RECEIPT DATE: 5/24/23 **ONSITE SEWAGE DISPOSAL SYSTEM** P 574142

PROPERTY ADDRESS: 14005 Clarksville Pike

**SEPTIC SYSTEM
 INSTALLATION SITE PLAN
 14005 CLARKSVILLE PIKE**

From: Silvast, Zackary
Sent: Tuesday, September 26, 2023 2:38 PM
To: Luke Groom
Cc: Paul Cavanaugh; Williams, Jeffrey; Wolf, Kevin; Page, Shepsura; Bernard, Dana
Subject: regarding 14005 Clarkesville Pike OSDS plan revision comments.
Attachments: 14005 Clarkesville Pike specs (most recent).pdf

TRENCH/DRAINFIELD DATA

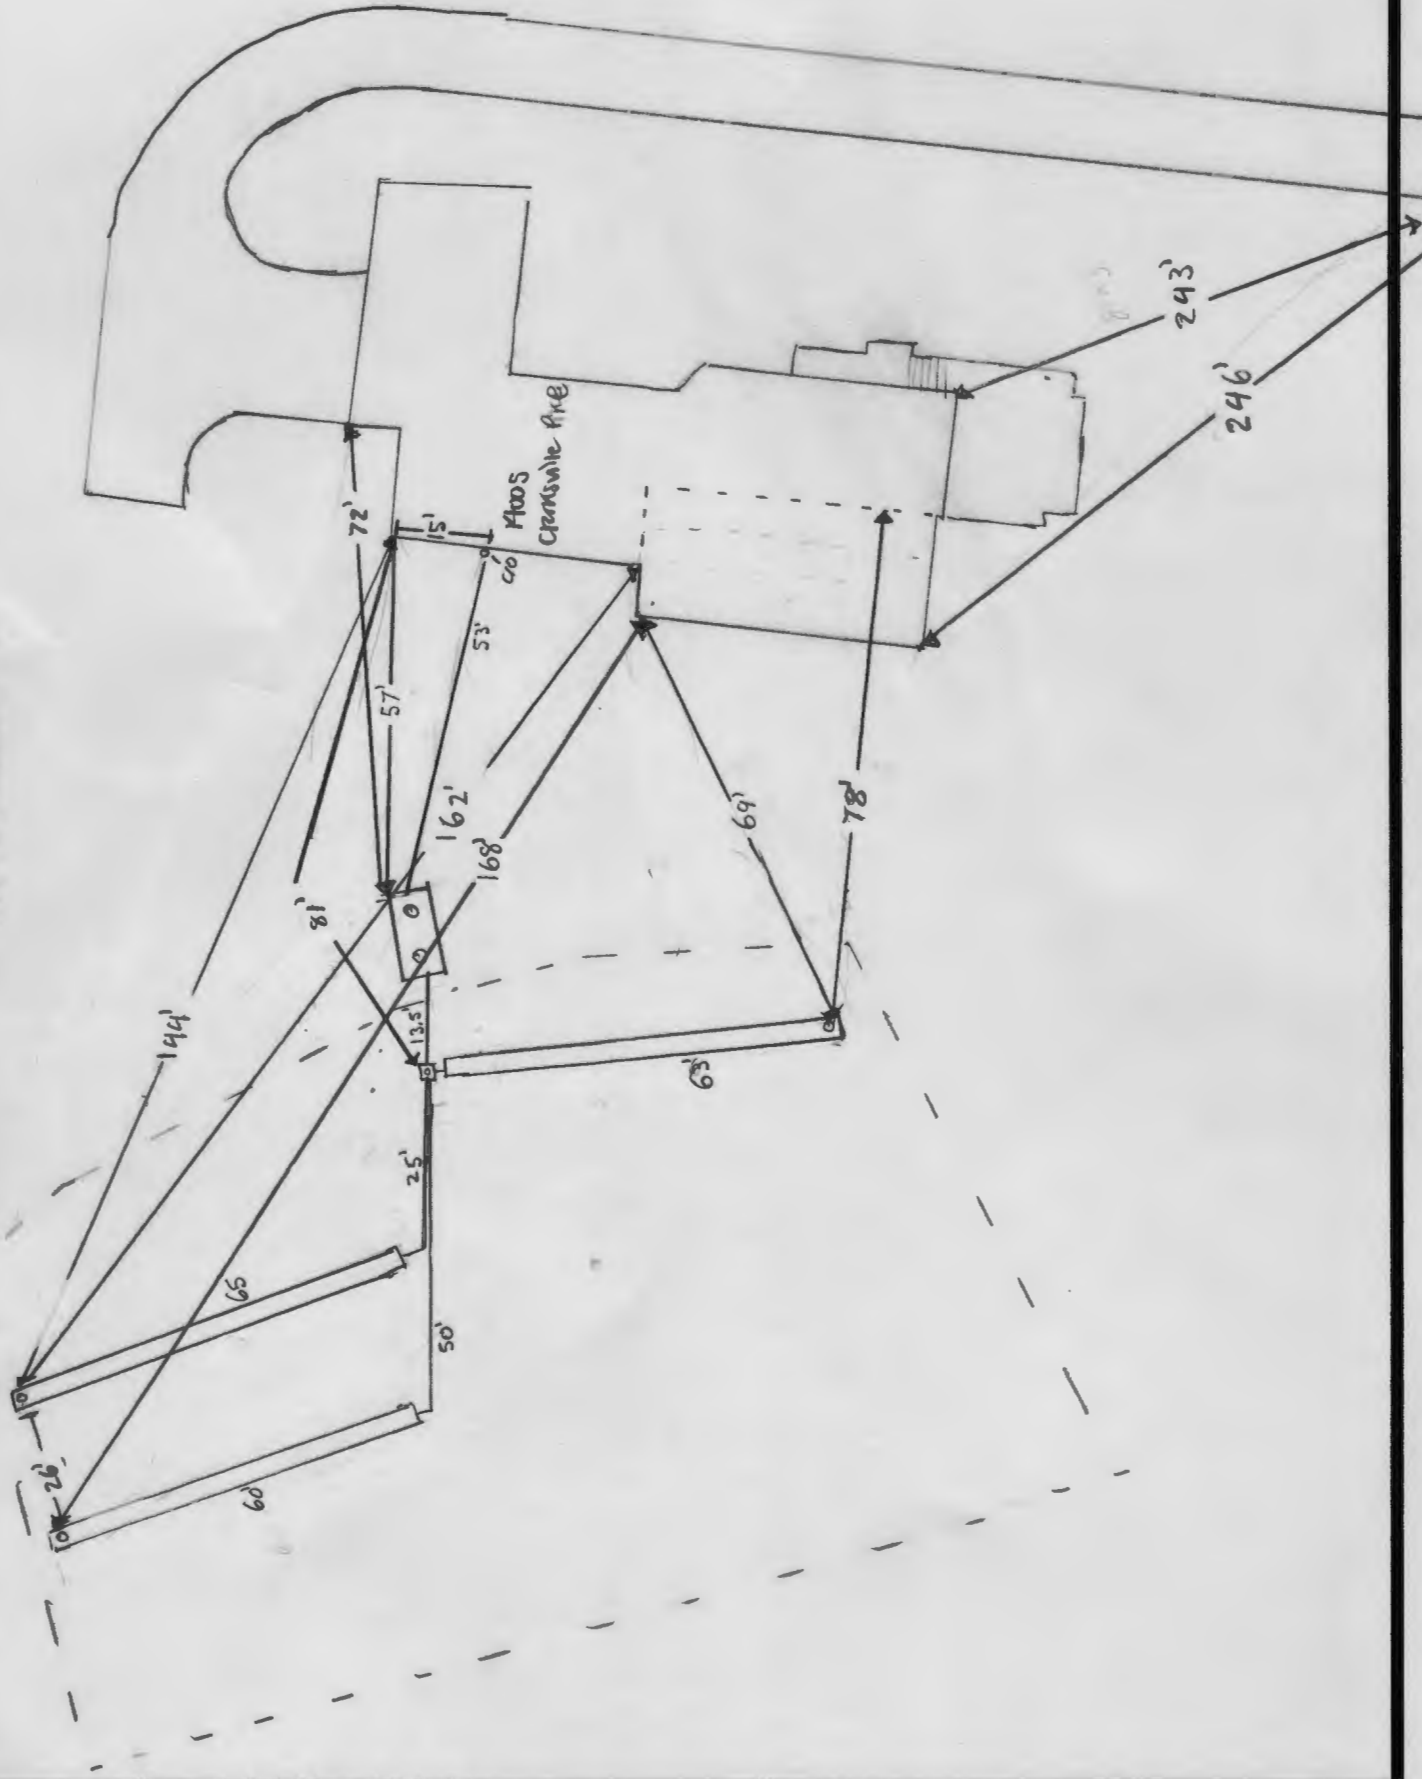
10/15/2023 - Installer & builder made for pre-con. Installer stated they would take all part of inlet line, regrade 200' around tank to plan, then re dig for inlet line & tank. SPT shown still on site. Measured 10' off old trench stakes for new stakes on plan. Upper & lower right trenches on center by 0.5'-3".
INSTALLATION: upper left trench will need to be widened about 12" when tank is set.
10/16/2023 - Builder changed grade, took utility to 18" (confirmed front line coming into tank has full. Stand while contractor dig hole for tank, waited for tank to arrive, arrived in good condition & has 2.5'-3' of cover.
10/17/2023 - Installer made for inspection. Started lower trench, bottom depth measured @ 2', still showing trench. Came back later in the day to see rest of lower & upper trench. Lower inlet @ 2'-2.5', upper inlet @ 4' but effective depth @ 6', did not take any effective sidewall. measured lower trench @ 60'. Did not see bottom in tank yet. Waiting for pre of plan for lower trench. Need to see 2 upper trenches still.

10/19/2023 - 2 upper trenches finished inlet @ 4'-4.5'. Contractor leveled box, inspector had to leave due to sickness.
